December 7, 2023
ES-8332.02

Earth Solutions NW LLC

**Subject: Geotechnical Addendum and Response to Correction Notice
2430 – 74th Avenue Southeast
Mercer Island, Washington**

Boring Location Plan
 74th Avenue S.E. Property
 Mercer Island, Washington

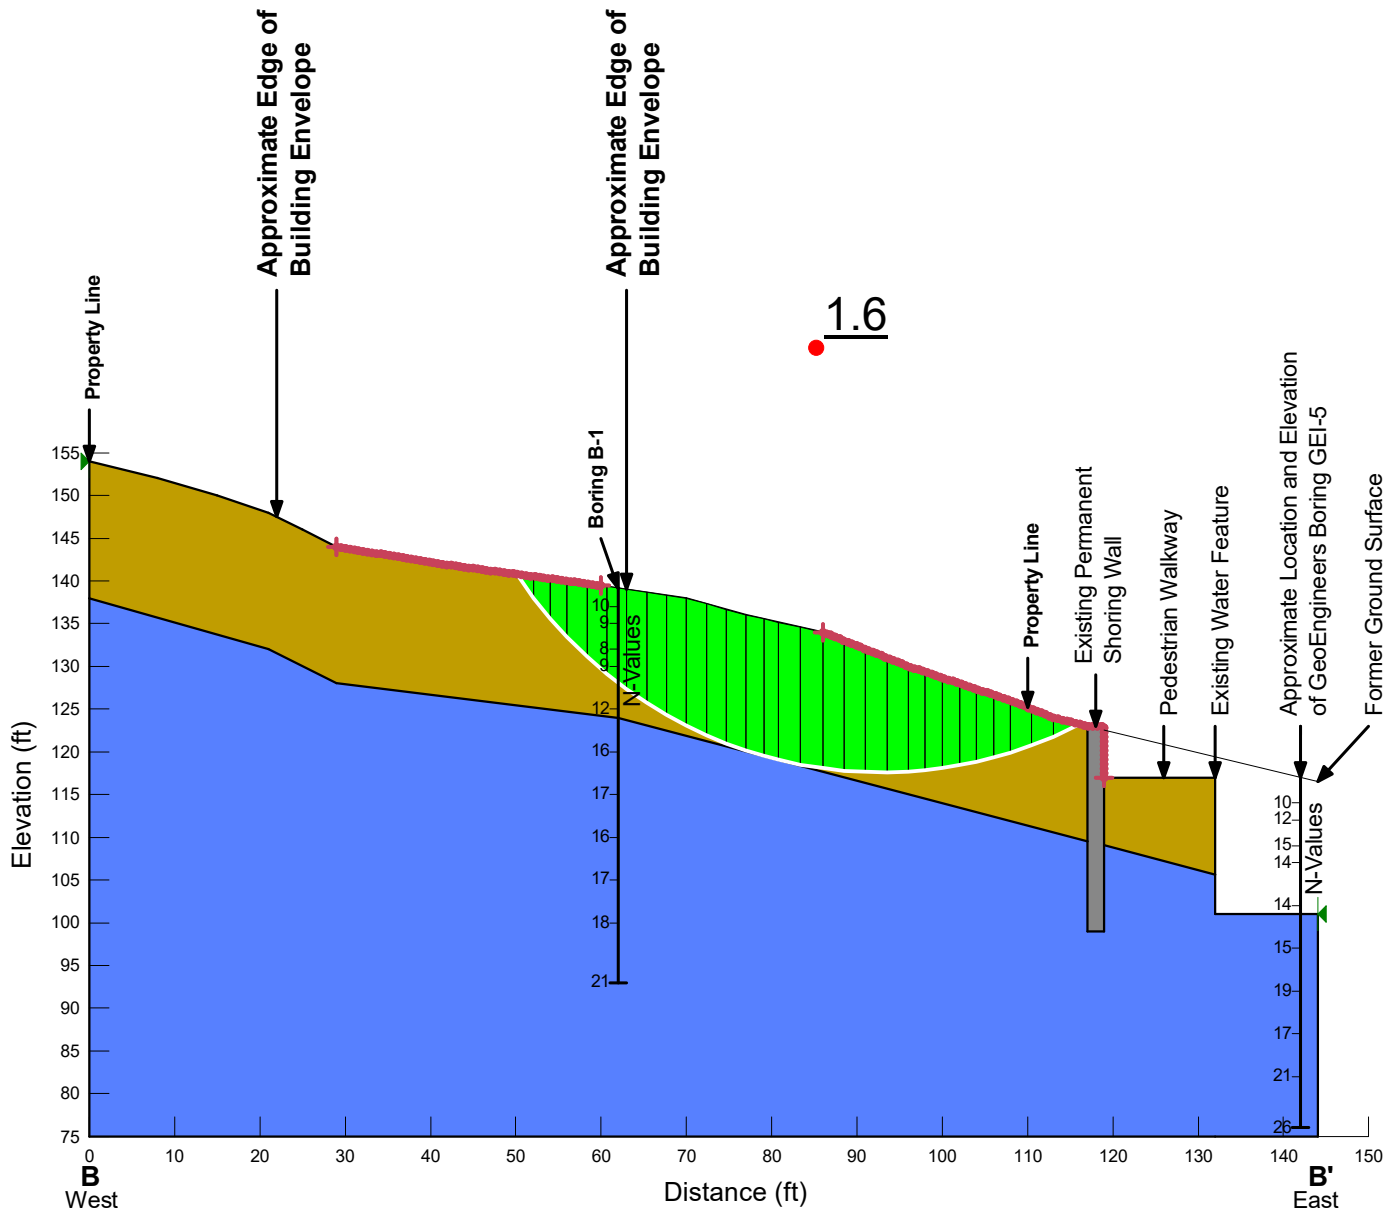
In revising the slope stability analyses, please justify stratigraphy used near the toe of the slope to the east. Existing subsurface information (City of Mercer Island website, map portal) suggests a thicker layer of disturbed soils than that shown near the toe of the slope on the current slope stability cross section.

Please revise section and slope stability analyses accordingly.

Updated slope stability analysis attached for the current lot. Stratigraphy was updated using a nearby boring log for the adjacent development and adequately describes the slope complex. Because there is a permanent shoring wall along the eastern property line for the adjacent development, our analysis does not evaluate deep-seated failure, as this system was presumably designed to resist this loading. Furthermore, the new residence will be supported on helical anchors which transfer loads deeper through softer soils into bearing strata; therefore, no additional loading of the slope will occur. In our opinion, the current stability modeling adequately captures the slope and affected area.

ES-8332.02
 74th Avenue S.E. Property
 Parcel B
 Cross Section B-B'
 Existing Geometry
 Seismic Condition
 Horizontal Acceleration = 0.329

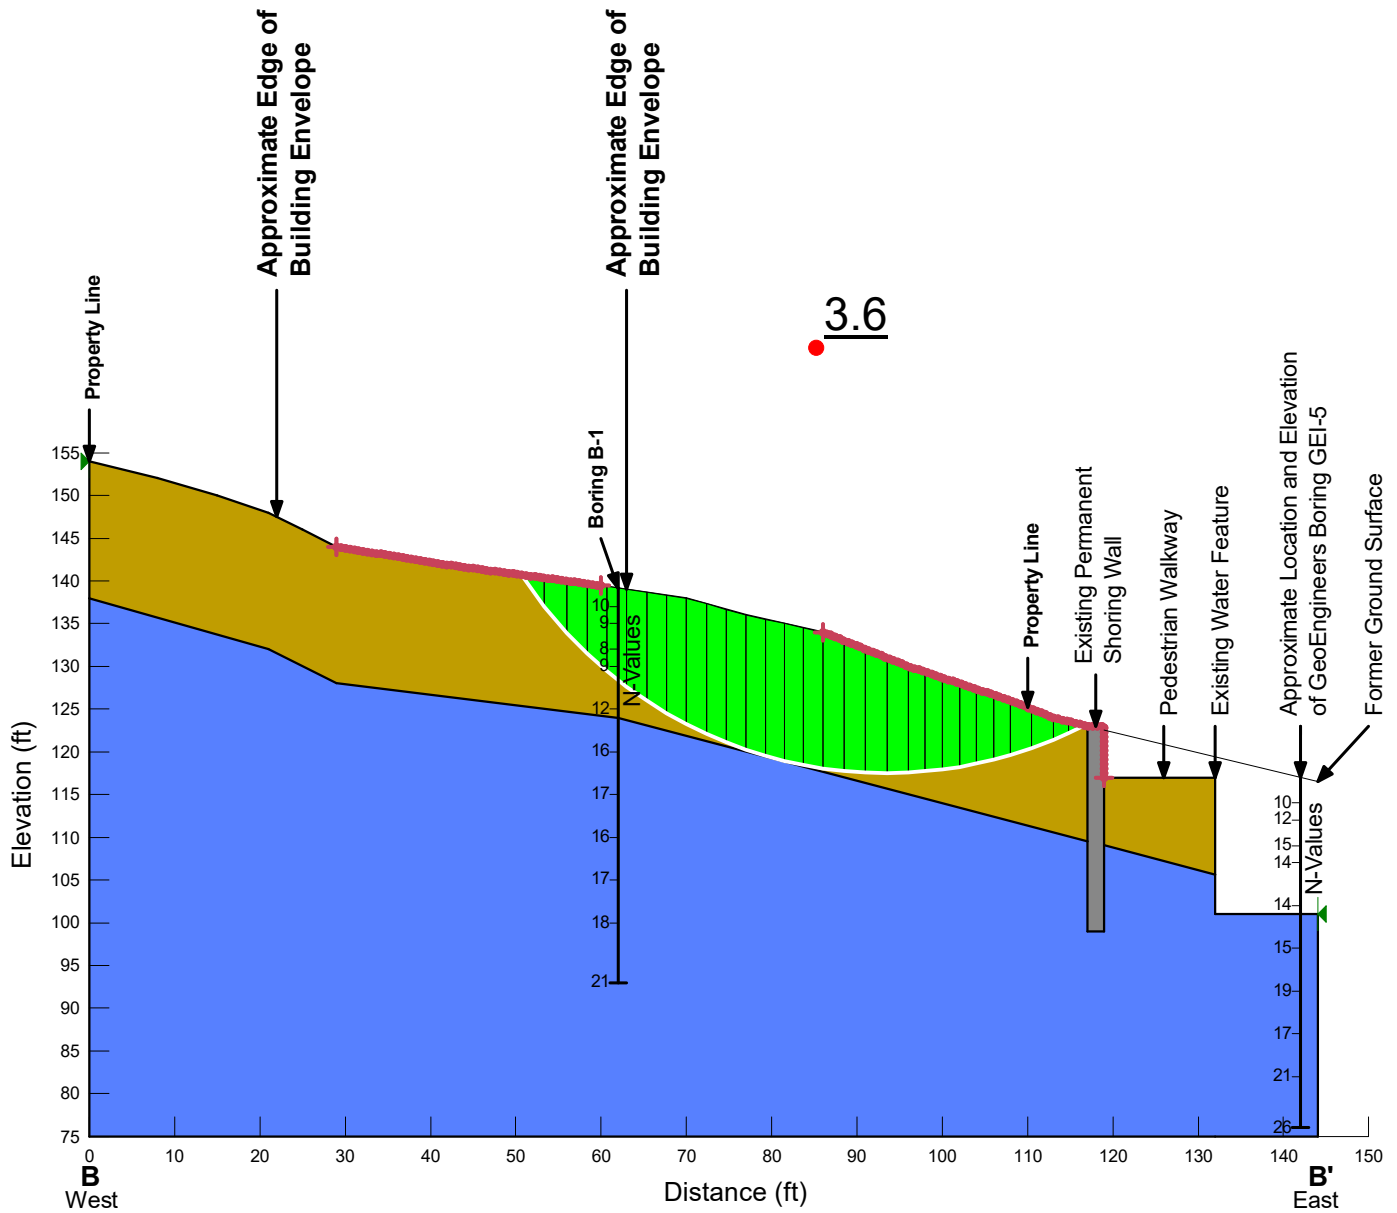
Assuming that Earth Solutions NW is the geotechnical engineer of record, please revise geotechnical report dated May 2, 2023 to reflect currently proposed development. Please update slope stability analyses to reflect current lot being developed.

Updated slope stability analysis attached for the current lot.

The results provide an adequate minimum factor of safety for static and seismic conditions.

The results provide an adequate minimum factor of safety for static and seismic conditions.
